Working Party on Lighting and Light Signalling (GRE)

Proposal for Supplement 5 to the 04 series of amendments to Regulation No. 19 (Front fog lamps)

Submitted by the expert from Germany*

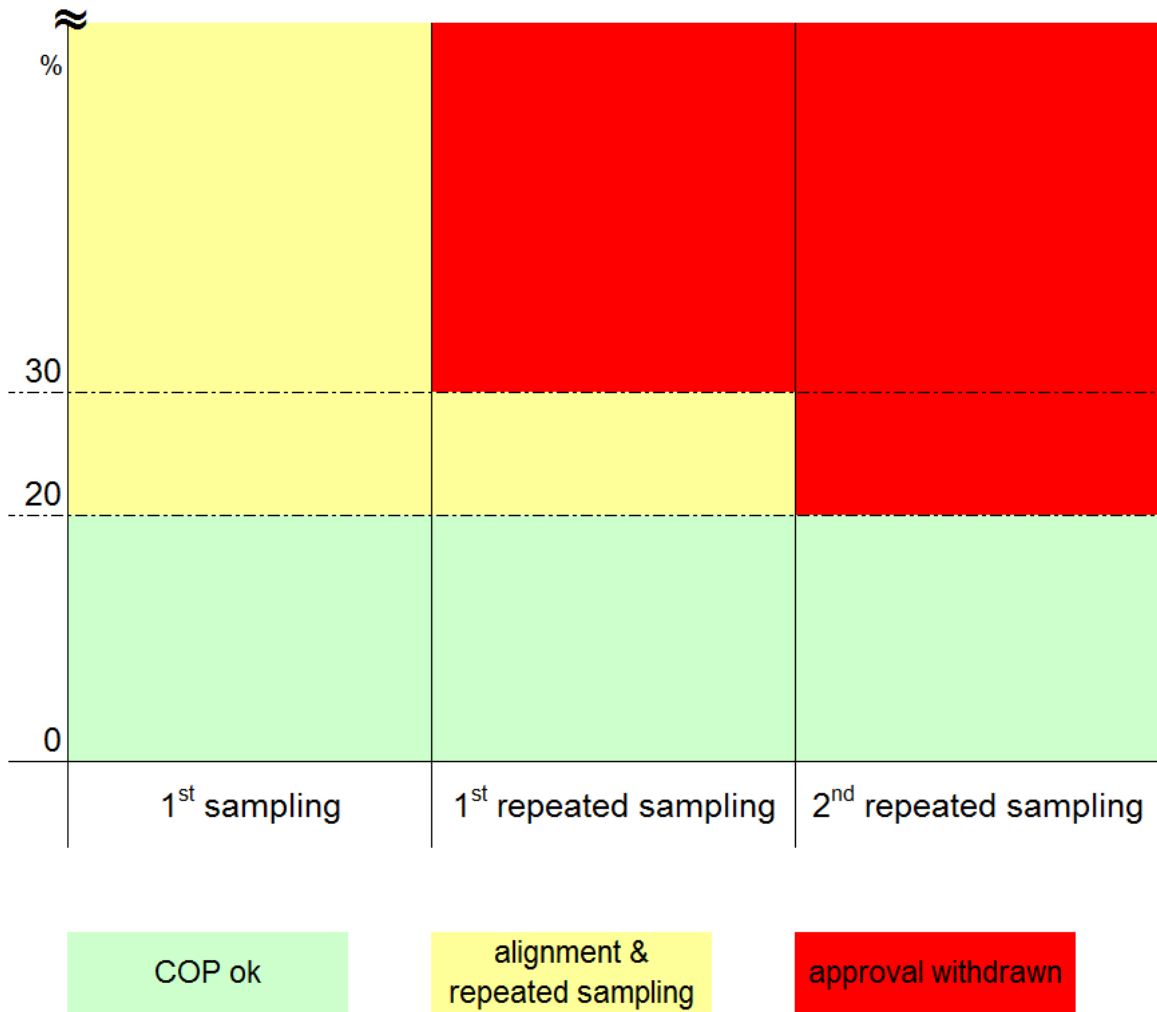
6. CoP is now described in a clear structured stepwise process (with limited steps), which gives the manufacturer the chance in the first step - in the case of deviations of more than 20 per cent - to align his production process. Also, the CoP process can be completed earlier when the first two samples are in the full specifications.

7. The proposal details the "third step" which defines the condition where the approval shall be withdrawn, when after the second repetition of this process the manufacturer was not in the position to "align" his production process in the correct way.

8. The attached drawing shall demonstrate this stepwise process.
